September 7, 2023

Re: Comment Response Letter:
Rod and Wire Mill 2022 IM Report
Area A: Parcel A3
Tradepoint Atlantic
Sparrows Point, MD 21219

Figure 22
 Cross-Section C-C'
 (Revision 1)

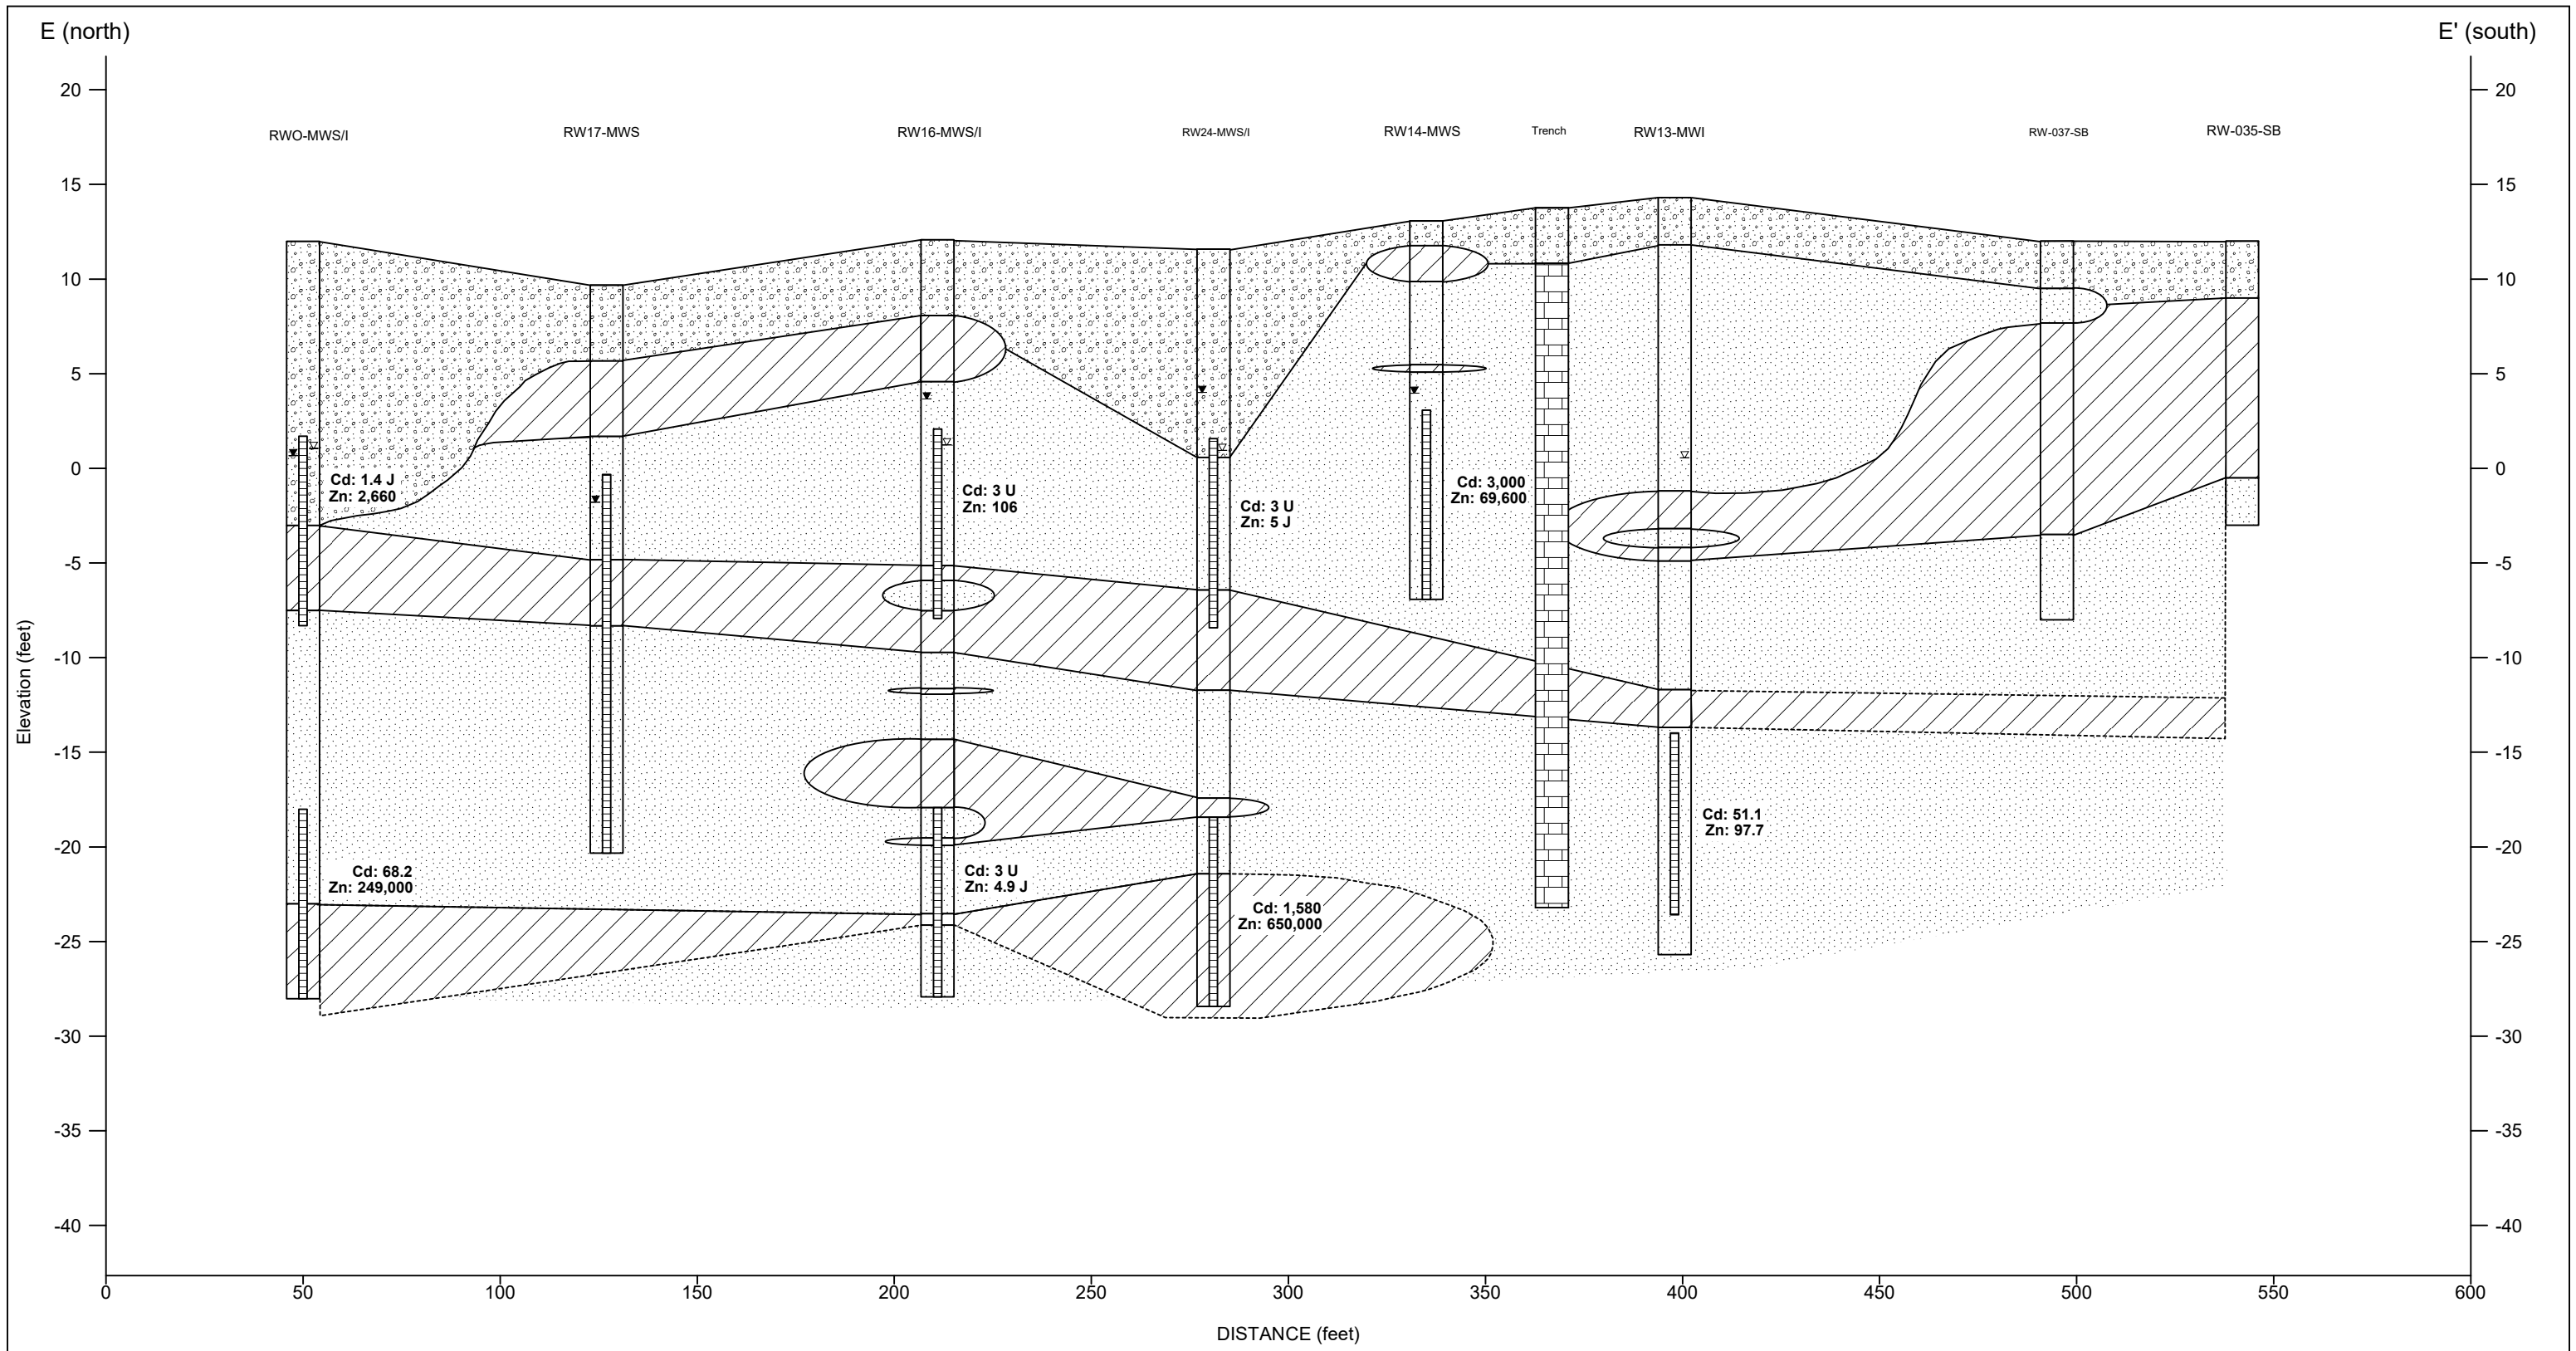
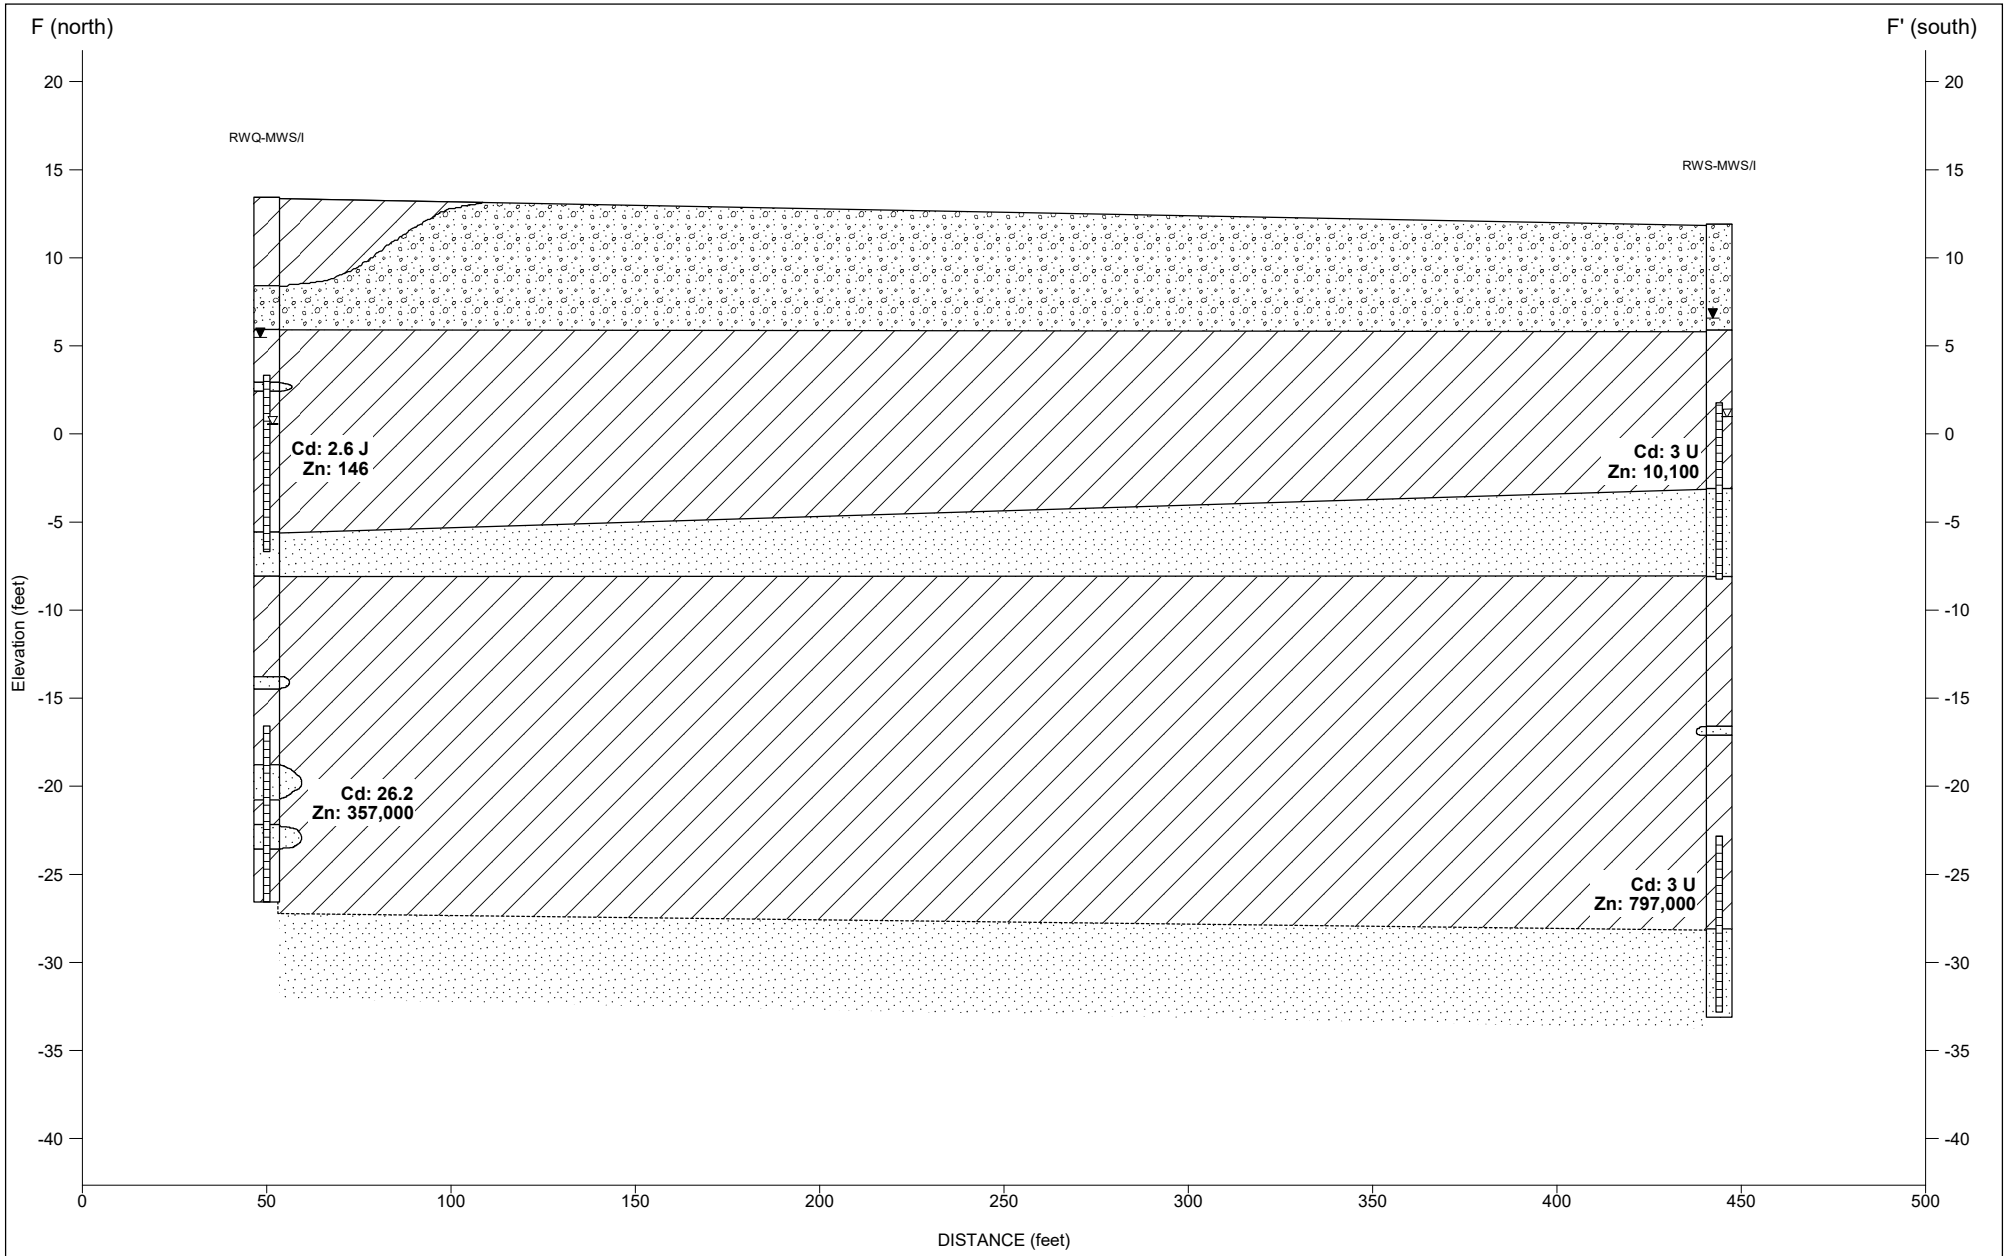
- *Additionally, Section 3.1 stated that groundwater flow in the intermediate zone is approximately 5 ft/yr. If RWK-MWI and RWL-MWI are located ~10 and 20 feet, respectively*

from the trench, and the trenches were installed in early 2017, it stands to reason that groundwater treated in the trench has already reached these two monitoring wells. Please provide a brief discussion on the stratigraphic sequence corresponding to the shallow and intermediate groundwater zones.

Response: As part of the RWM Supplemental Investigation Report (Revision 1, April 8, 2020), there is a detailed discussion of site geology, site hydrogeology, groundwater flow, and hydraulic gradients. Cross sections were also included in this previous submittal. All cross sections are included as Attachment 1 to this CRL for reference.

RWM Shallow GW Elevations

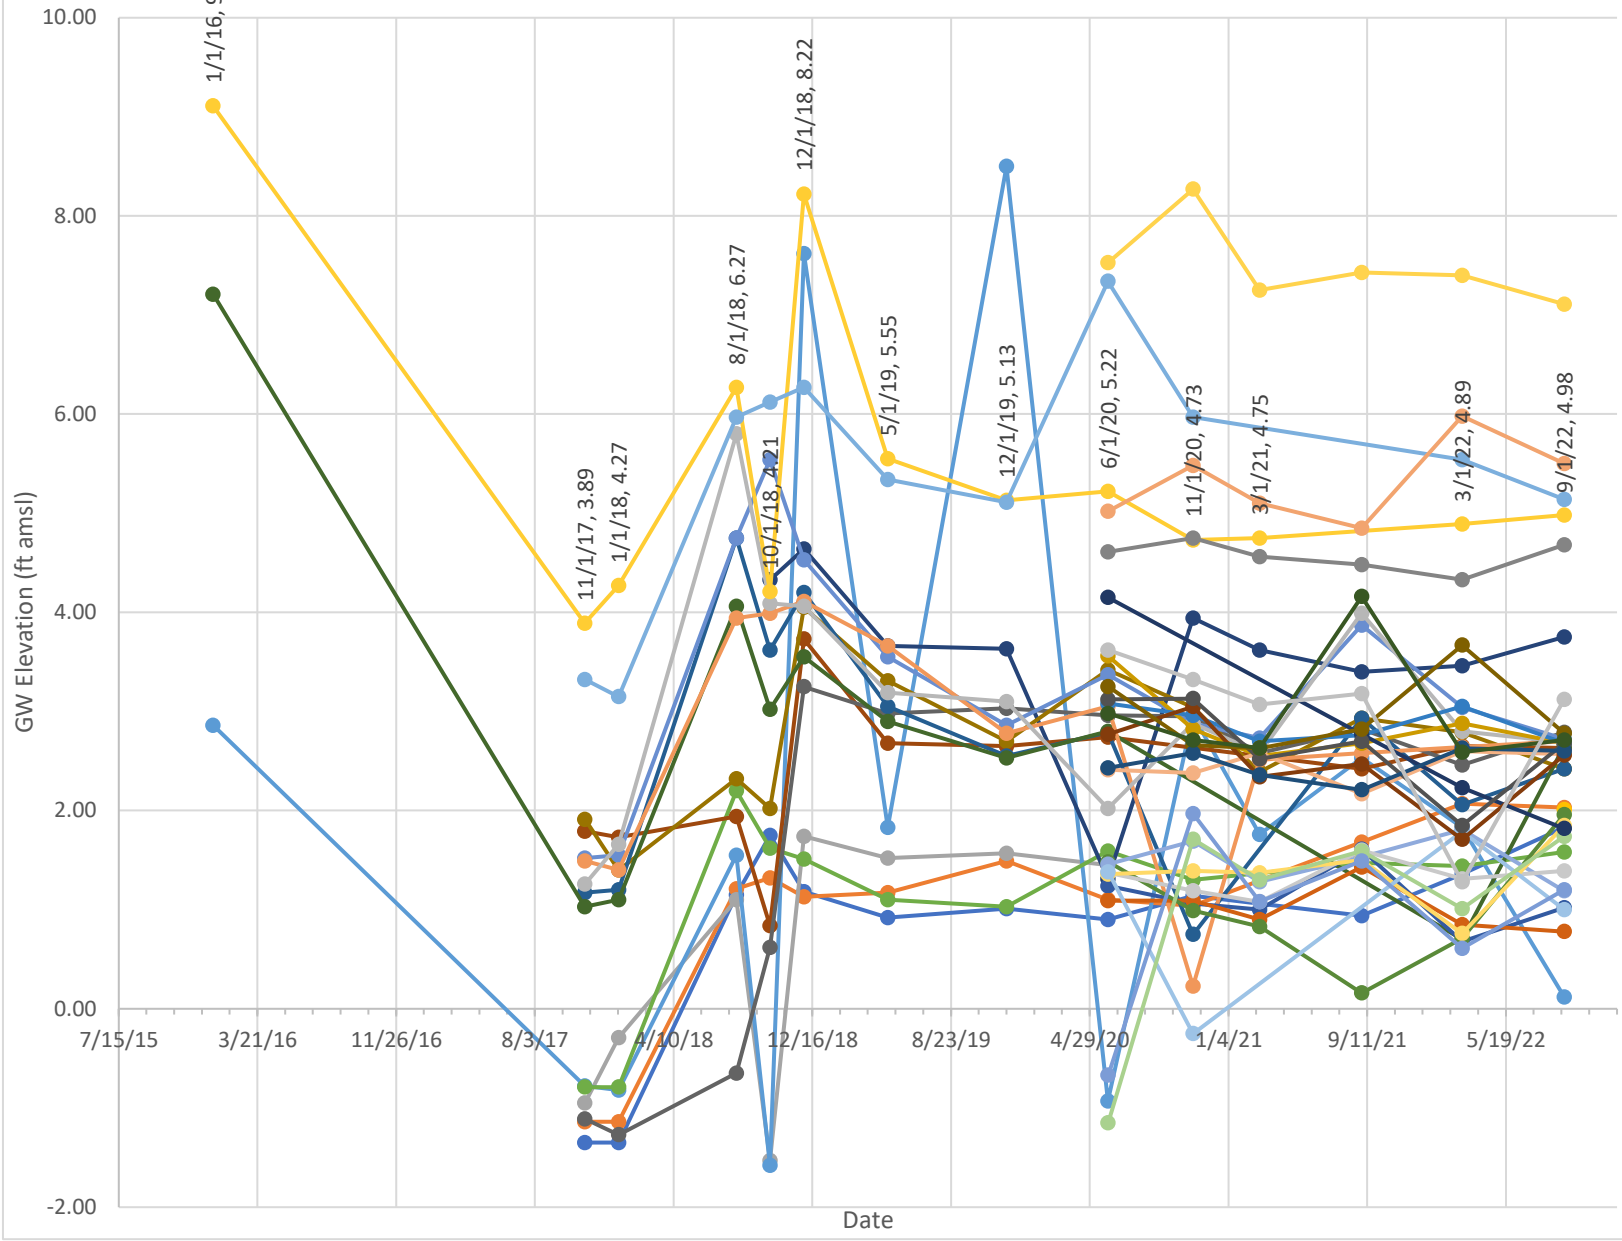
- *The text indicates that groundwater elevations were higher in Q3 than in Q1. Is this a seasonal variation that is observed annually or was gauging done after a rain event, etc.?*

Response: The gauging events were completed on March 21 and September 7, 2022. A review of historical precipitation data for the Baltimore area indicates the most recent rain events were March 17, 2022 (0.38 inches) and September 6, 2022 (1.38 inches). So, it is possible that the increase in groundwater elevations in the Fall 2022 gauging event is partially attributable to the recent rain event. Text has been added to Section 3.3.2.1. However, no clear seasonal trends are observed when looking at groundwater elevations over time. Wells within paved and unpaved areas were also considered, with no clear trends (refer to Attachment 2 to this CRL).
